# **Accufacts Inc.**

**November 3, 2014**

**Re: Review of Algonquin Gas Transmission LLC’s Algonquin Incremental Market (“AIM Project”), Impacting the Town of Cortlandt, NY, FERC Docket No. CP14-96-0000, Increasing System Capacity from 2.6 Billion Cubic Feet (Bcf/d) to 2.93 Bcf/d**

## Exhibit 2 – AIM Project Overview Map from DEIS Showing General Location of Replacement of 26-inch with 42-Inch Pipeline Across Cortland, NY

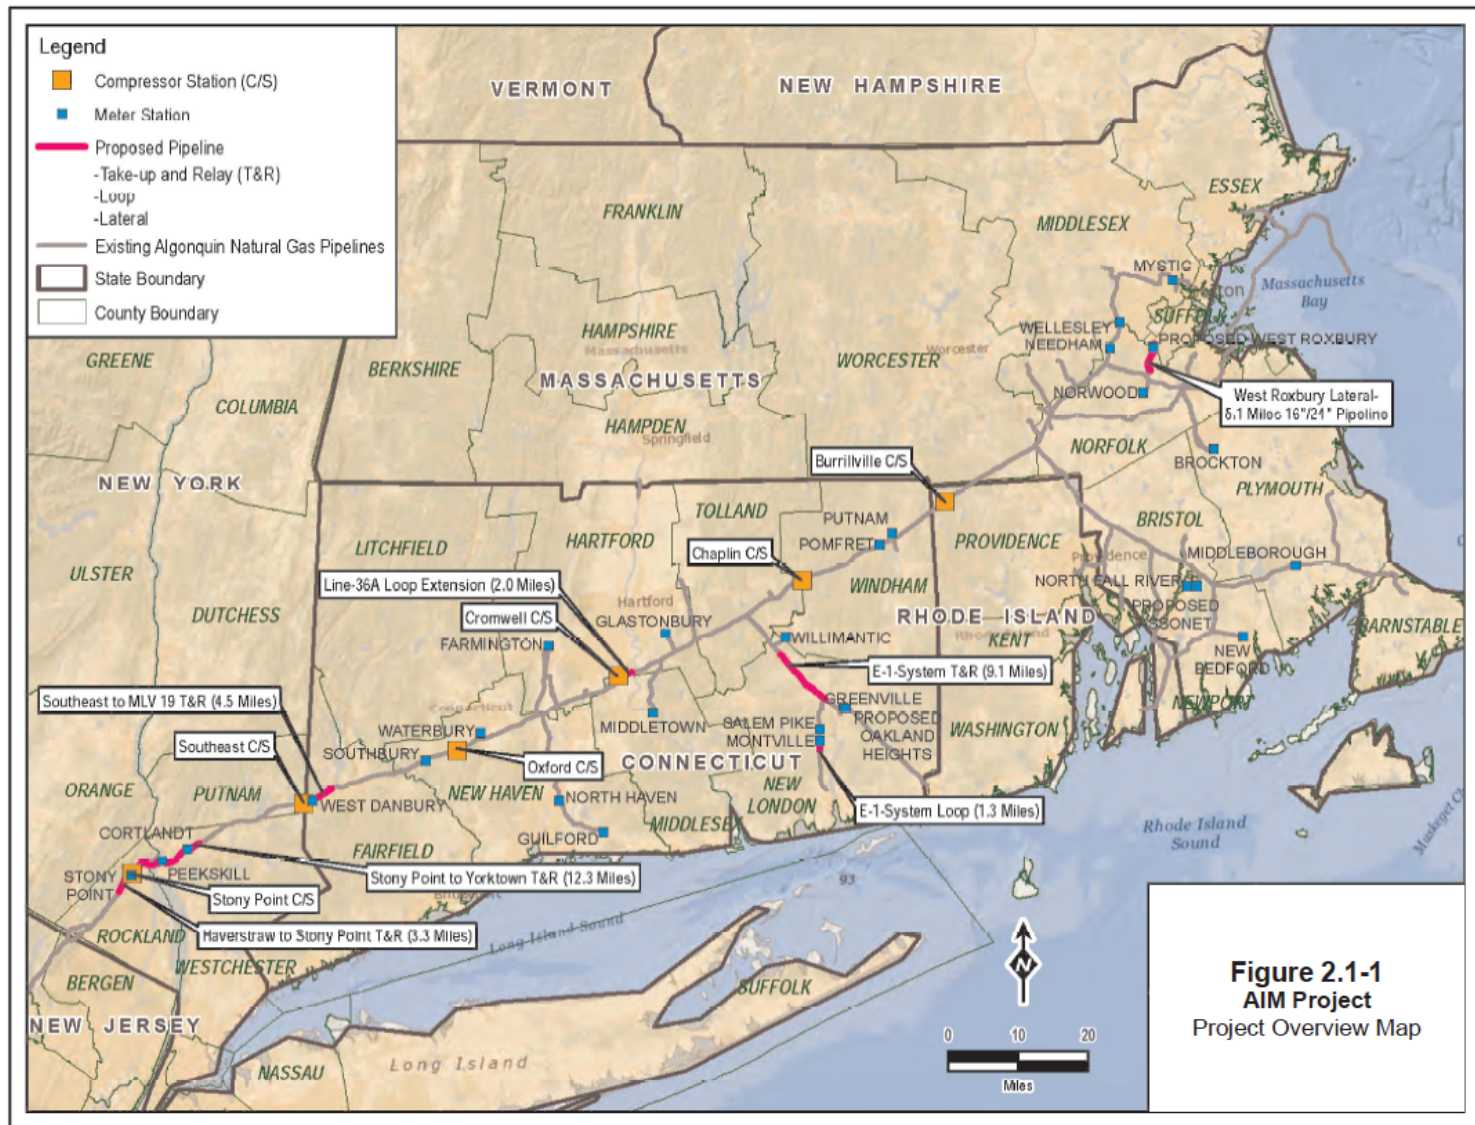
- 2) Exhibit 2 is a figure captured from the AIM Project DEIS showing the relative location of where the existing 26-inch pipeline will be removed and replaced by new 42-inch pipeline that AIM has labeled “Take-up and Relay (T&R),” in essentially the same right-of-way (“ROW”) through most of Cortlandt.<sup>6</sup>
